REQUEST FOR COUNCIL ACTION

SUBJECT: An Ordinance amending the Newberg Comprehensive Plan, VIII. 2017 Water Master Plan incorporating the Addendum Riverfront Master Plan 2021 into the Newberg Comprehensive Plan

Staff: Doug Rux, Director; Brett Musick, Heidi Springer
Department: Community Development
File Number: CPTA20-0003

Incorporates the Addendum Riverfront Master Plan 2021 into the 2017 Water Master Plan.

FIGURE 7-1

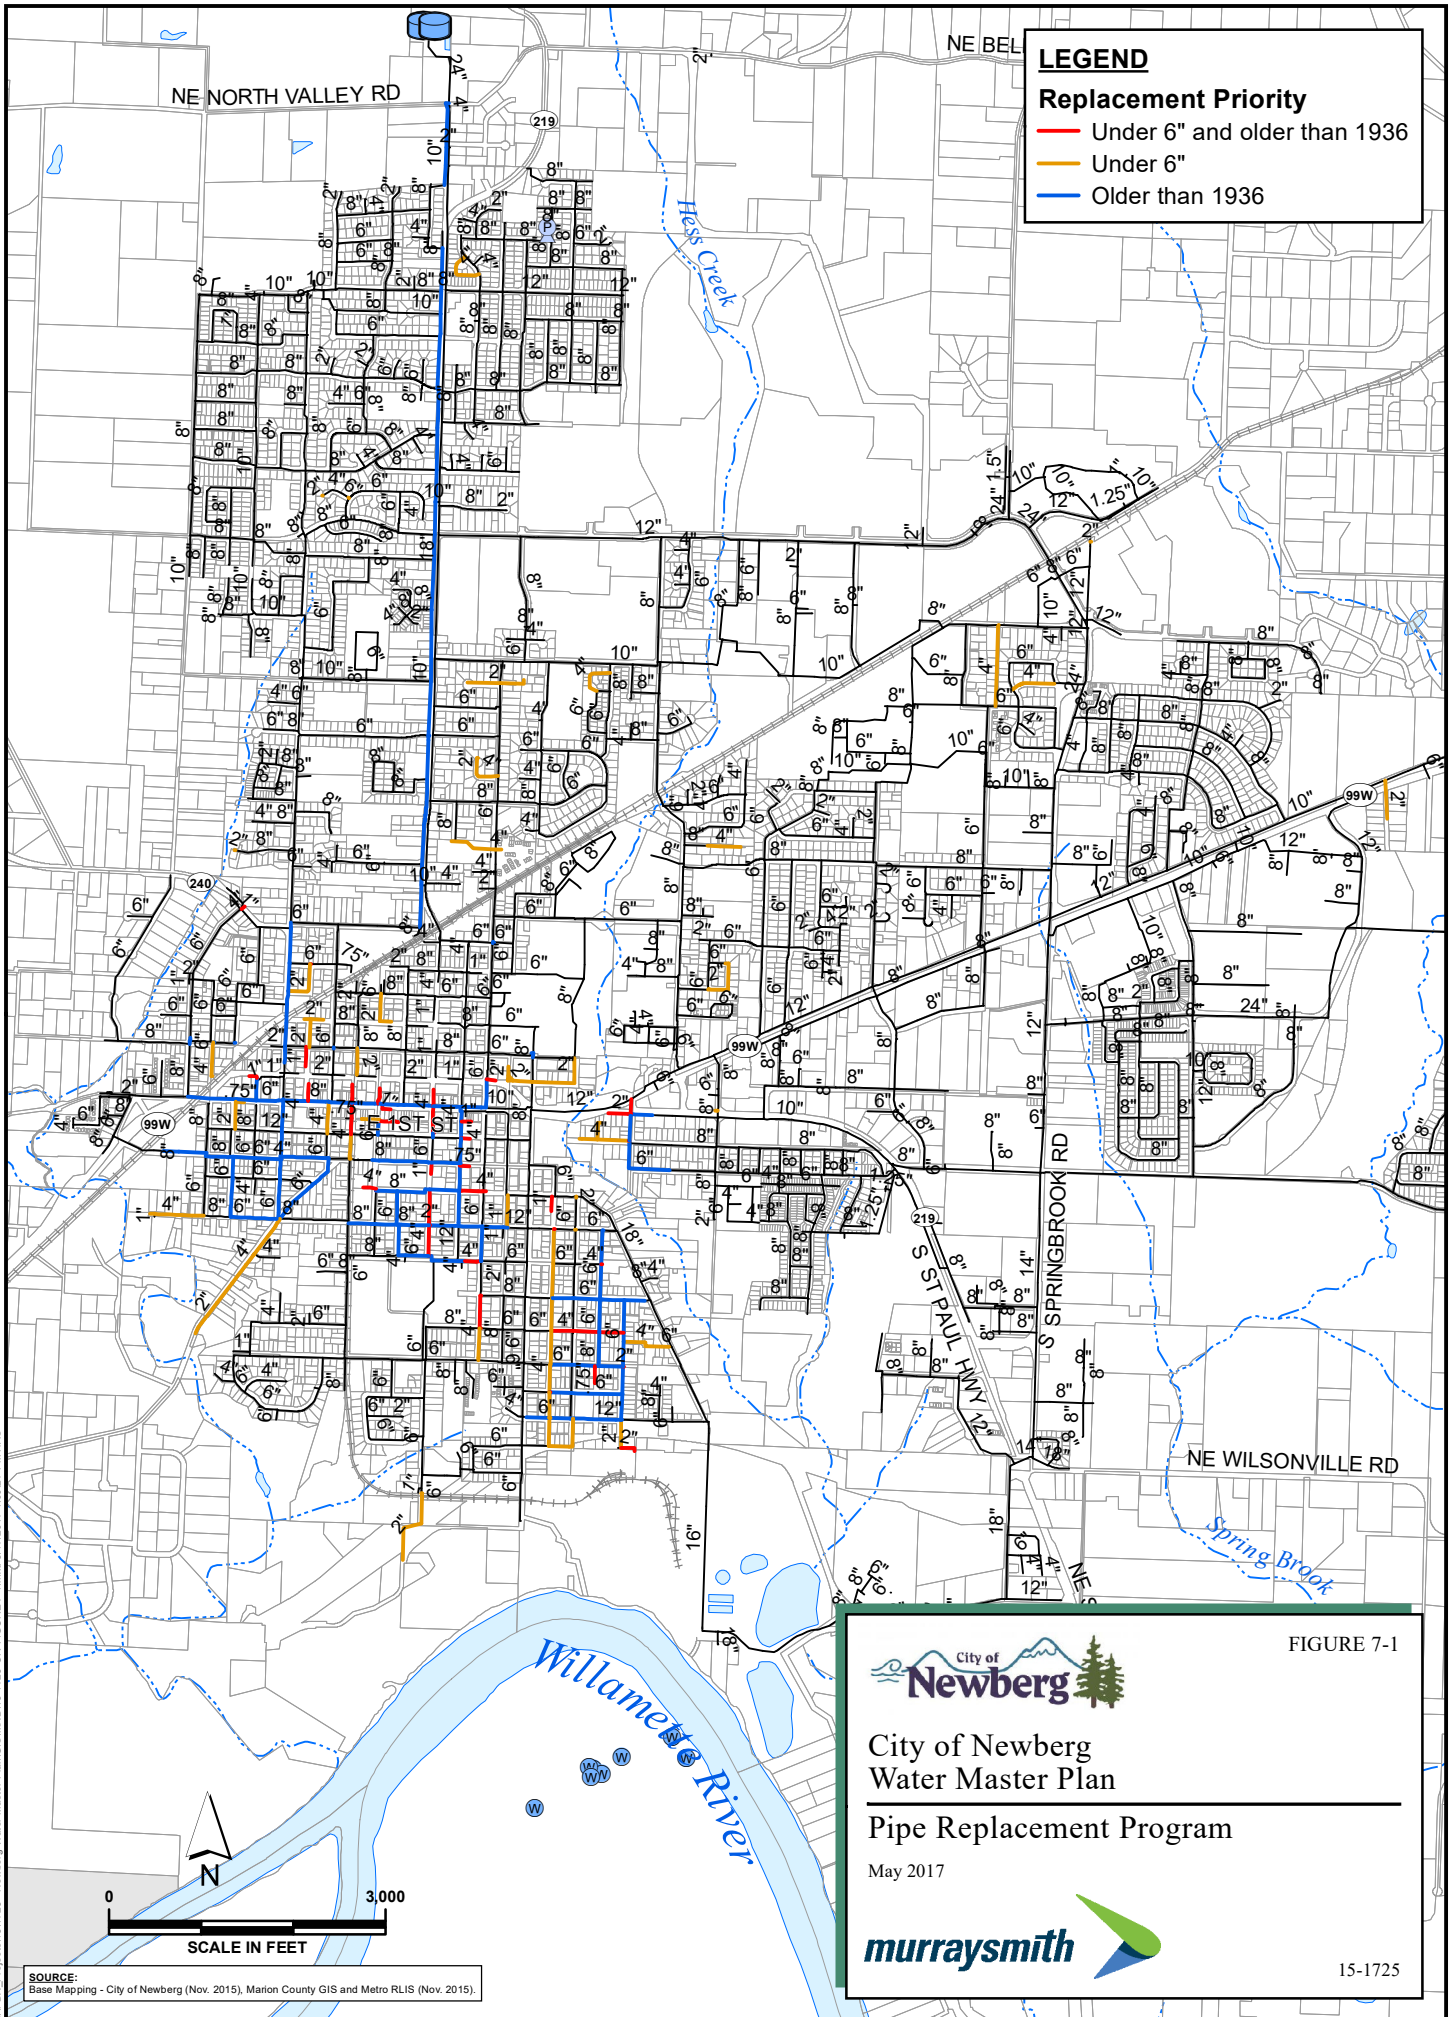
Note 1: See Appendix E, Addendum Riverfront Master Plan (Adopted 5/3/21)

Figure 1
 Estimated Water Demand – Future Riverfront Development

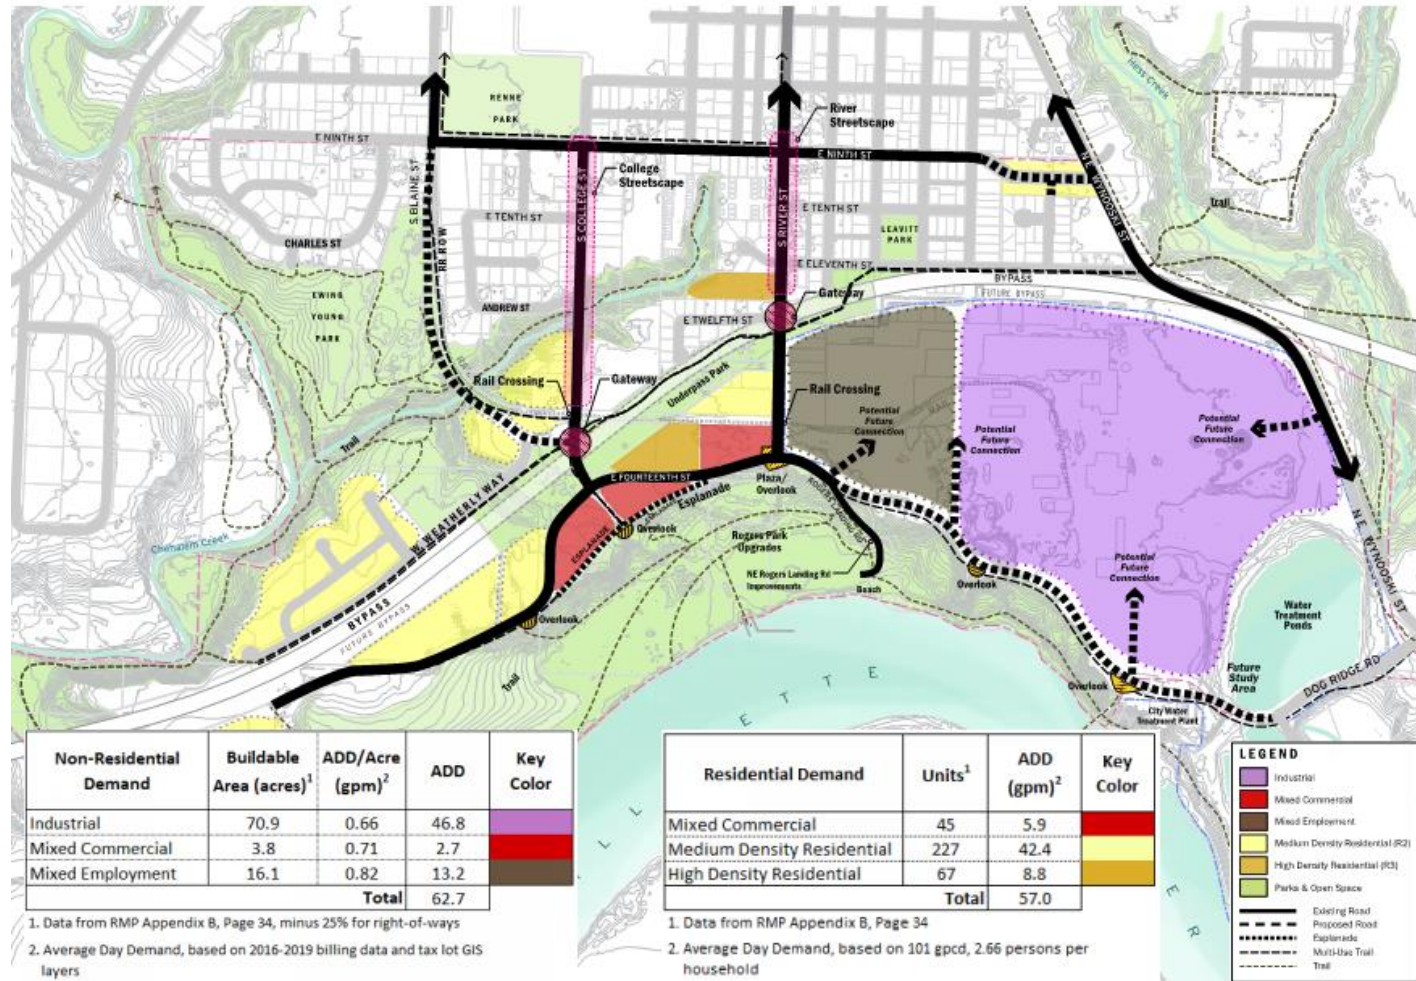
The Riverfront area was outside of the anticipated future water service area in the 2017 WMP, thus projected demand for this area must be added to projected 20-year demands from the 2017 WMP. Potential development in the Riverfront area is estimated based on anticipated land use described in the RMP Appendix C Preferred Alternative E. Future water demand is estimated by applying an average water use per acre (non-residential) or per unit (residential) based on 2019 City water billing records. **Figure 1** illustrates estimated water demand. **Table 2** summarizes projected 20-year water demand [Table 2-3, page 2-5] including the Riverfront area.

**Figure 2
 Riverfront (RMP) &
 Middle Housing (IBTER)
 CIP Projects**

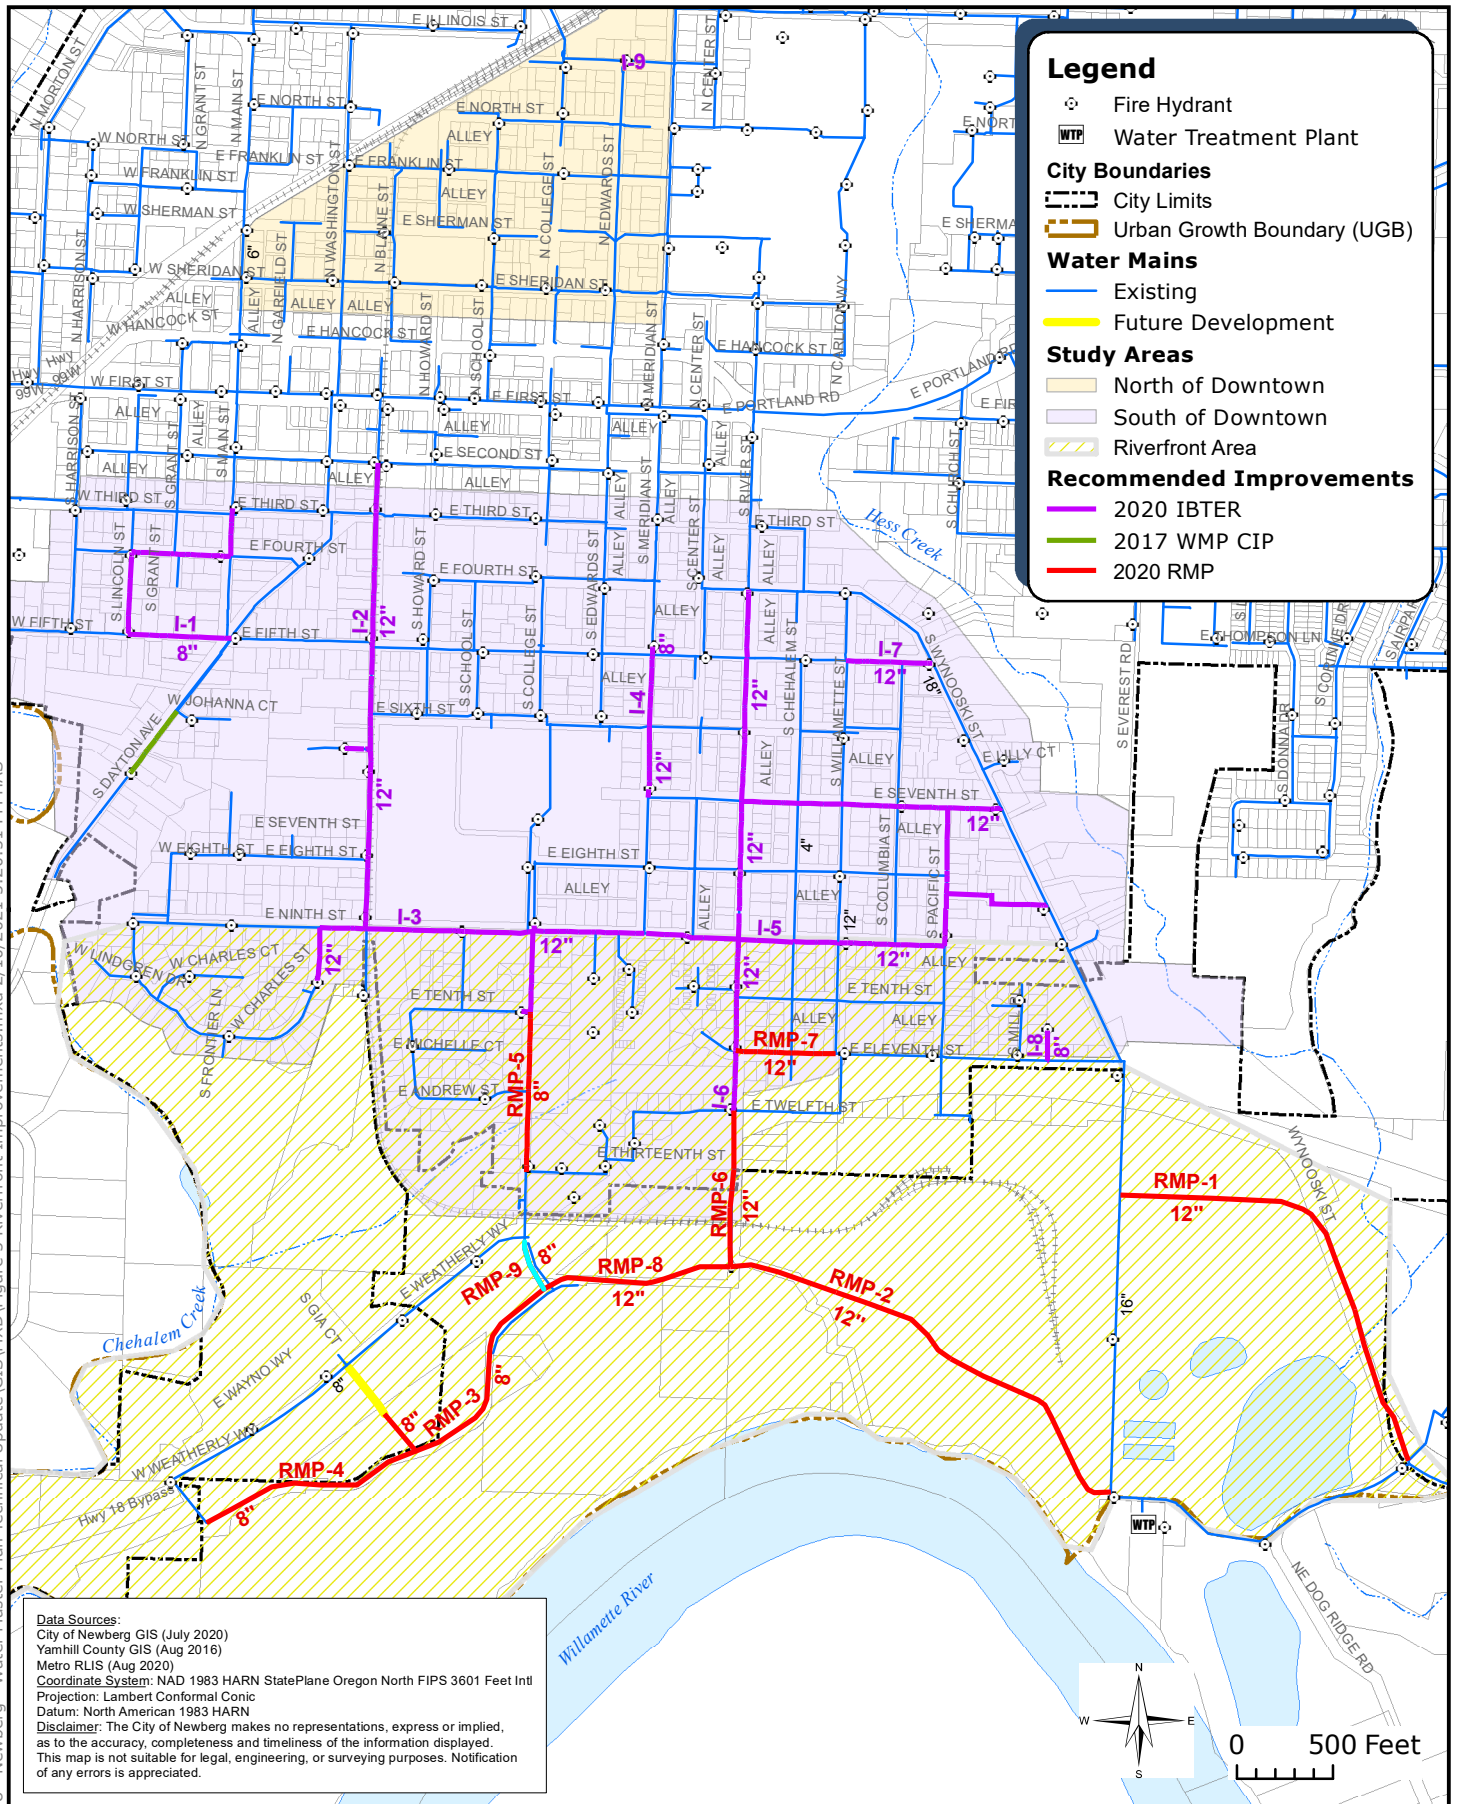
Riverfront and IBTER piping improvement CIP projects are illustrated on **Figure 2** at the end of this memo and summarized in **Tables 5** and **6**.

Distribution main alignments to serve future Riverfront development are based on proposed roadway alignments from the RMP and preliminary site plans from the Riverrun development on the north side of W Weatherly Way. Riverfront distribution mains are sized based on the projected 20-year demands summarized in **Table 2** and required fire flow based on proposed zoning from the RMP Appendix C Preferred Alternative E zoning as presented in **Table 4** and **Figure 1**.
